Addendum No. 2

**DATE:** January 19, 2017  
**TO:** ALL PLANHOLDERS OF THE DOWNTOWN PARKS PROJECT  
**FROM:** YAT CHO – CITY OF MORGAN HILL  
**RE:** Clarifications

Page(s) 42.

5'-0" TALL CHAIN LINK FENCE WITH BARBED WIRE NTS

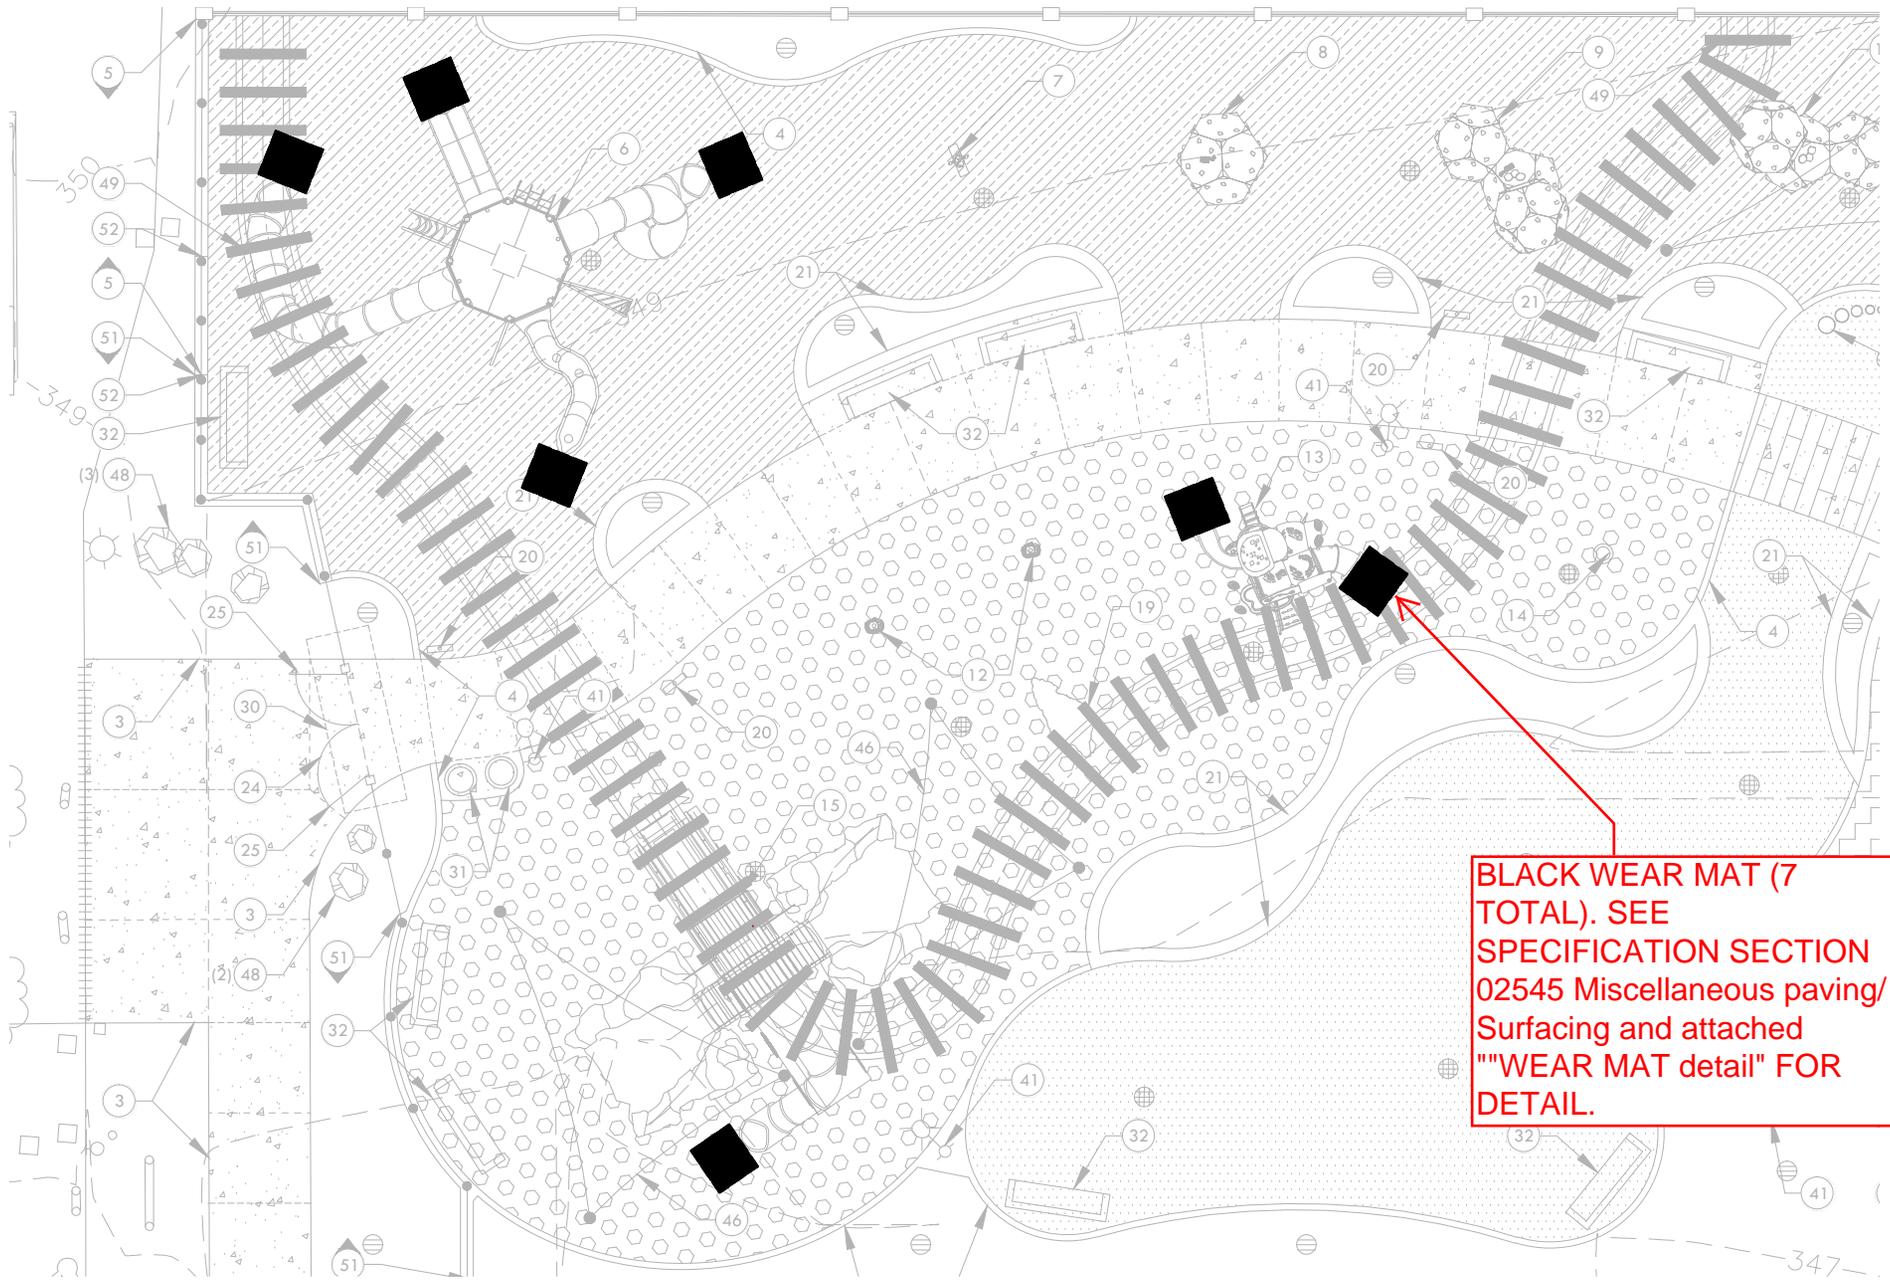
2. The new fence note #19 on sheet L6.1 should be a 5' high chain link fence without top and bottom rails, with arms. In addition, there shall be a (3) strand barbed wire to match existing chain link fence around existing water tank. See attached chain link fence detail.

**BLACK WEAR MAT (7  
TOTAL). SEE  
SPECIFICATION SECTION  
02545 Miscellaneous paving/  
Surfacing and attached  
"WEAR MAT detail" FOR  
DETAIL.**

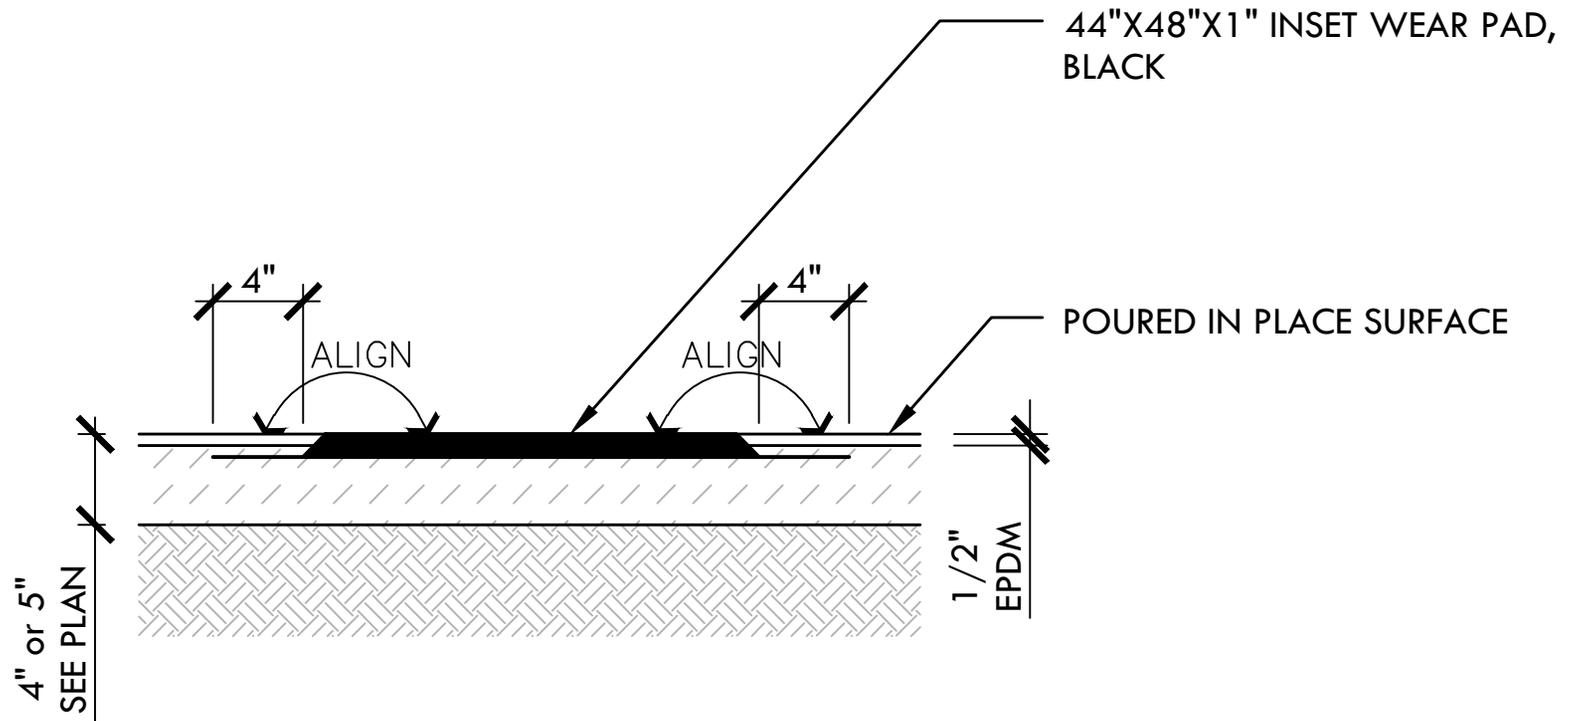
12. Question: Can you please provide a detail of what is expected as a 1" Wear Mat to be installed as part of the Poured-In-Place Resilient surfacing?
  1. Attached is the detail for the Wear Mat to be installed along with a drawing noting the locations of the Wear Mat at Depot Park.

**VEHICLE BRIDGE PLAN**  
SCALE: 1" = 5'

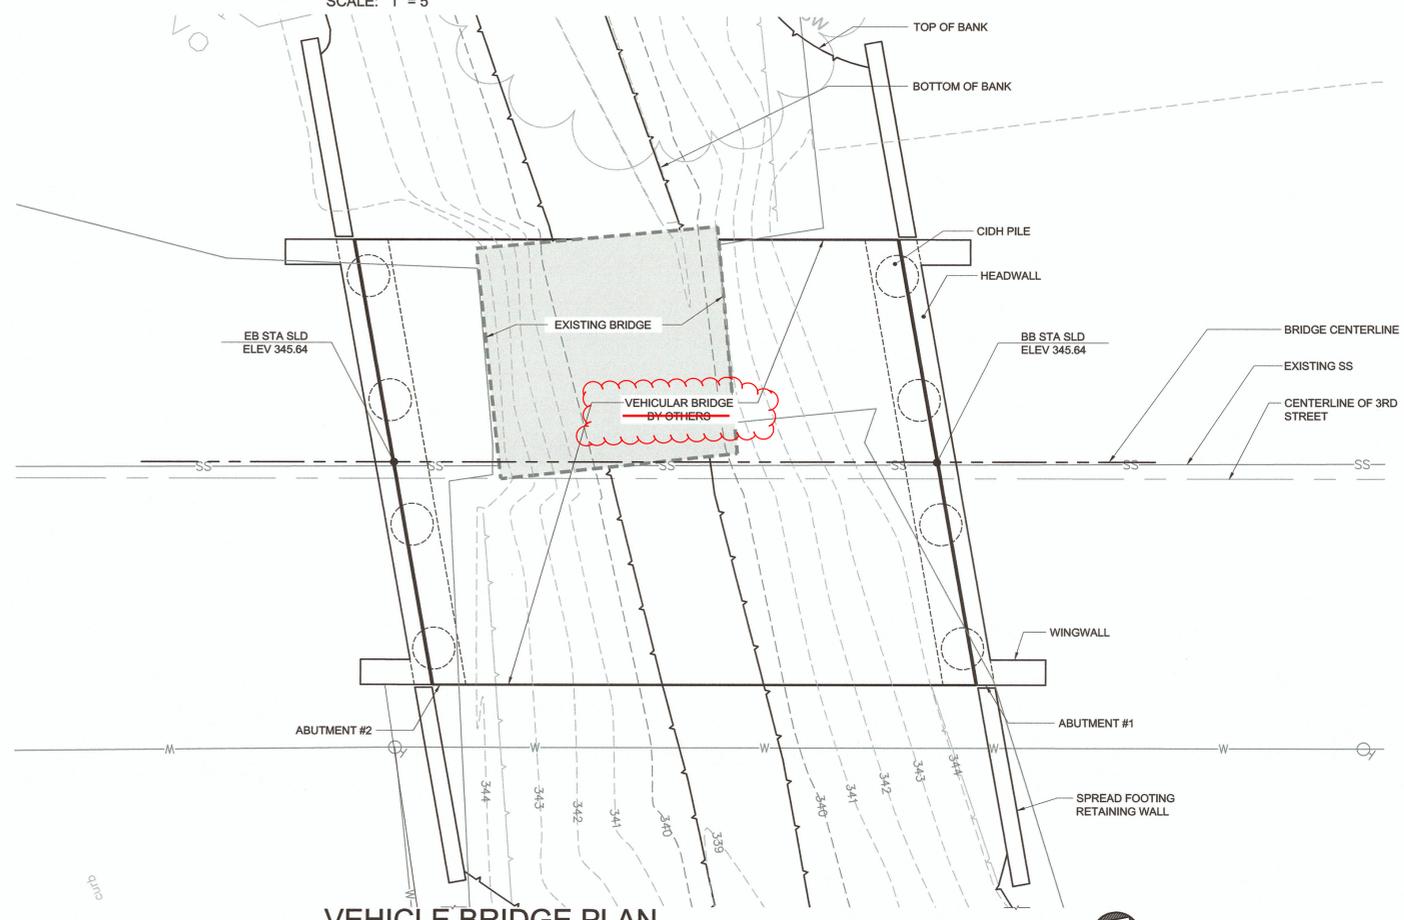
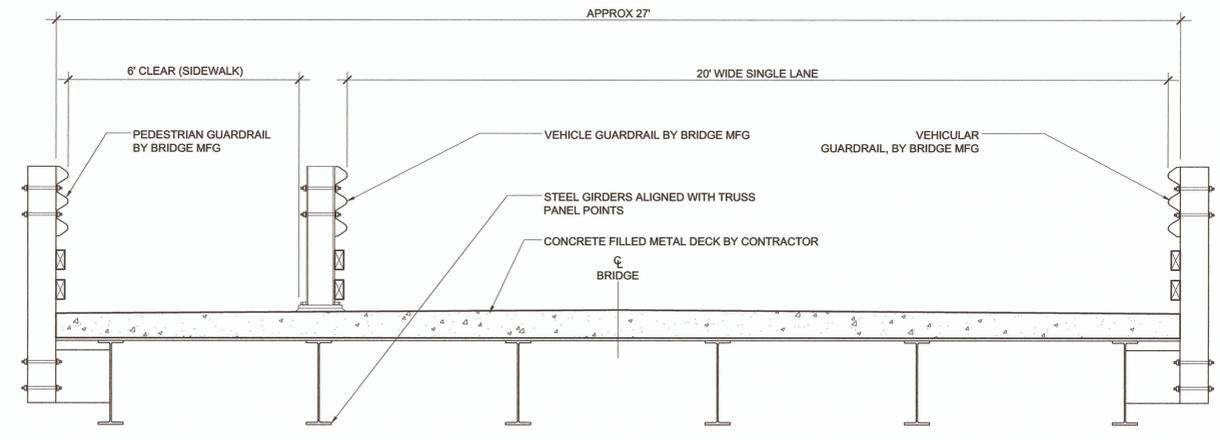
13. Replace VEHICLE BRIDGE PLAN with attached VEHICLE BRIDGE PLAN on Sheet S3.0 of the Little Llagas Creek Park.
14. The rubber mat to be installed at Hilltop Park for the fibar surfacing is not specified. Please advise.
